**LANDMARK COMMISSION****April 6, 2026**

FILE NUMBER: COA-26-000056  
LOCATION: 5020 Swiss Ave  
STRUCTURE: Contributing

1. A Certificate of Appropriateness to replace existing French doors on south elevation with French doors to match existing.
2. A Certificate of Appropriateness to replace and resize existing bay windows on south elevation.
3. A Certificate of Appropriateness to replace and enclose existing non-original door on west elevation with window and salvaged brick.

**5020 Swiss Avenue**

02 - PARTIAL EXTERIOR ELEVATION - SOUTH  
SCALE: 1/4"=1'-0"

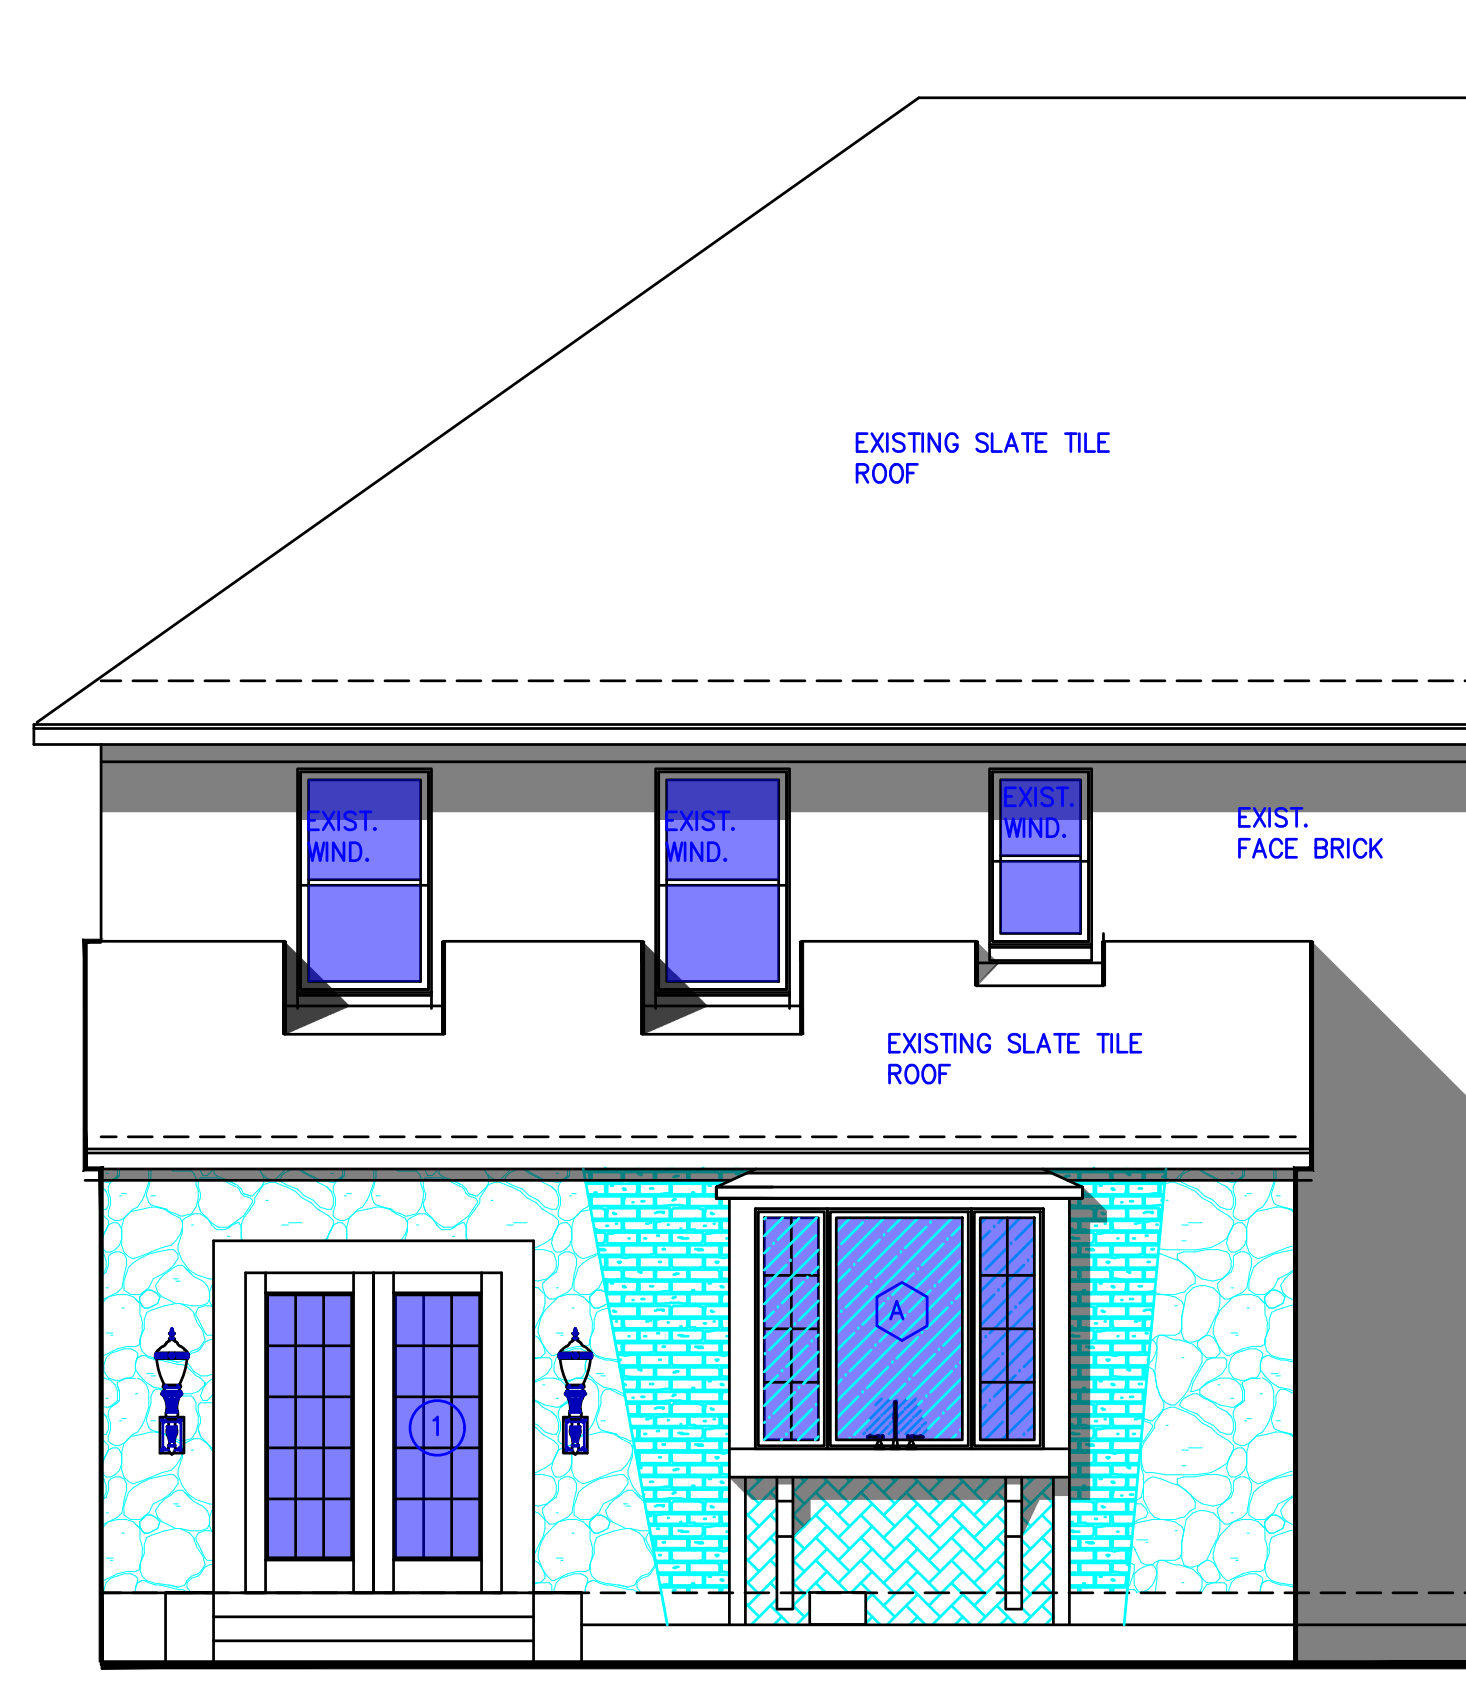
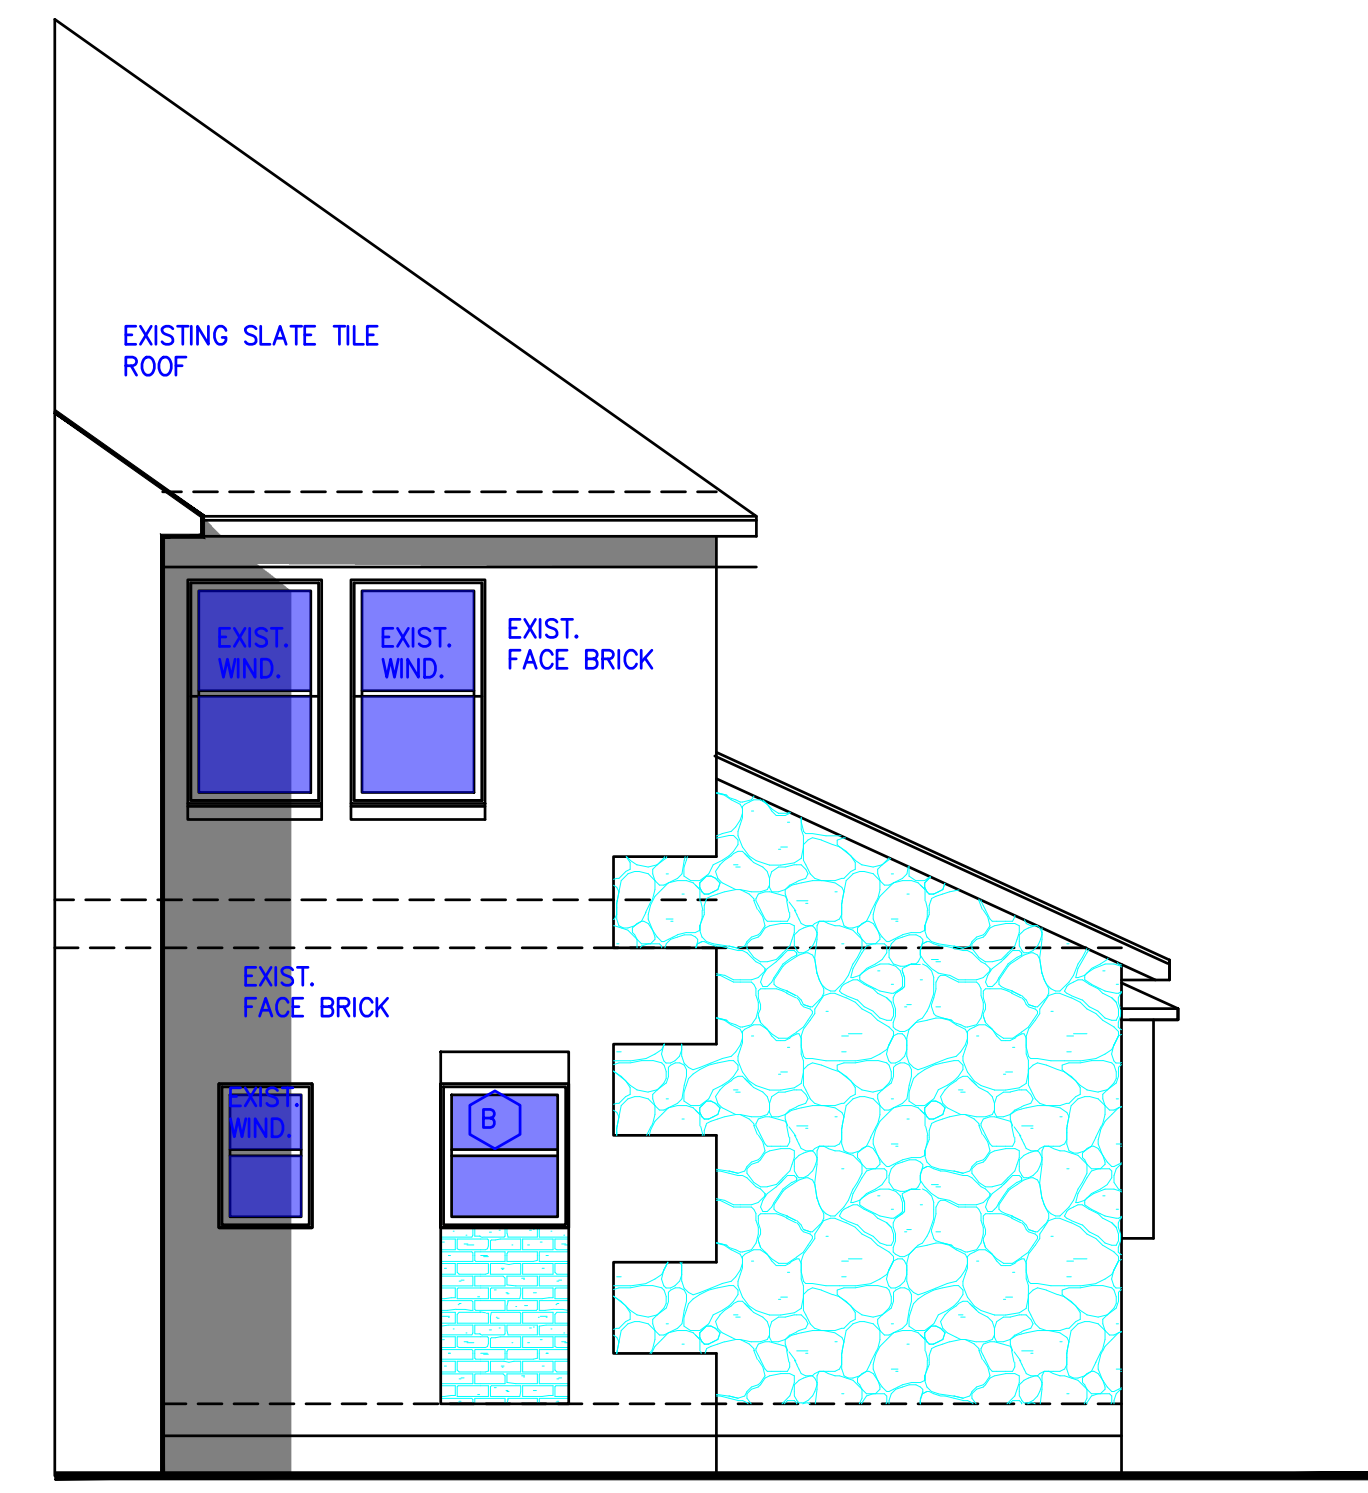
1. That the request for a Certificate of Appropriateness to replace existing French doors on South elevation with French doors to match existing be approved in accordance with drawings and specifications dated 4/6/2026. The proposed work is consistent with preservation criteria Sec. 51P-63.116(1)(P); City Code Section 51A-4.501(g)(6)(C)(i) for contributing structures; and/or the Secretary of the Interior's Guidelines for Rehabilitation (District/Neighborhood).

2. That the request for a Certificate of Appropriateness to replace and resize exiting bay windows on South elevation be approved in accordance with drawings and specifications dated 4/6/2026. The proposed work is consistent with preservation criteria Sec. 51P-63.116(1)(P); City Code Section 51A-4.501(g)(6)(C)(i) for contributing structures; and/or the Secretary of the Interior's Guidelines for Rehabilitation (District/Neighborhood).

*1. Bay windows - as submitted*

*2. French doors - as submitted*

REPLACE EXISTING  
DOOR WITH NEW DOOR  
TO FIT IN EXISTING  
OPENING

REPLACE THIS WINDOW EXTEND  
THE WINDOW DOWN AND REWORK  
BAY AND BRICK WORK BELOW
